Power Steering Hose Updated Repair Method

Topic number	LI46.00-N-069137
Version	3
Function group	46.00 General
Date	08-03-2020
Validity	906.xxx Sprinter all 907.xxx with code ZG3 (four wheel drive with selectable low range)
Reason for change	Validity extended
Reason for block

1_Return Line Matra
Clamp Arrangement.jpg:

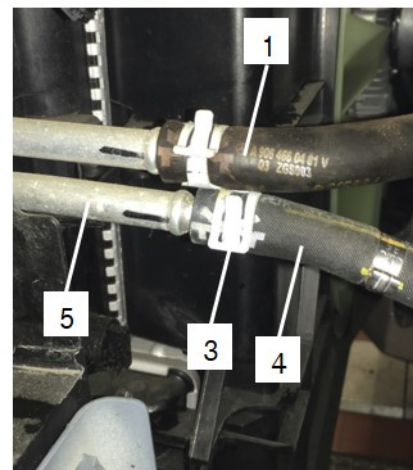
When repairing power steering hose connection to power steering cooler the clamp may not be positioned correctly

The clamp located on the steering gear return line may not be positioned correctly

Replace Spring Style Clamp with Screw Clamp (N000000 000665)

1. See WIS instructions AR46.25-D-3020-01SE (Disconnect / connect hydraulic lines on power steering cooler).
2. Clamp return line to reservoir (1) with Matra clamp (2) to avoid oil leaking.
3. Open clamp (3) using hose clamp pliers (W454 589 00 37 00) and remove return line to oil cooler (4). Clamp (3) can then be discarded.

3_Return Line Arrange-
ment with Screw Clamp.
jpg:

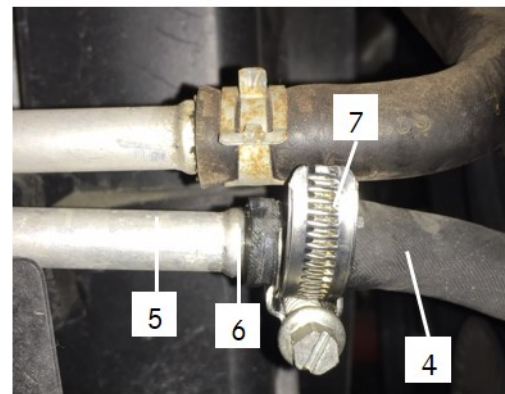
6. Install the screw clamp (7) on to the return line to the oil cooler (4).

7. Connect the return line to oil cooler (4) to the power steering cooler tube (5). To do this, push the return line (4) on to the cooling tube (5) as far as the stop (6).

9. Tighten the screw clamp (7) to 5 Nm.
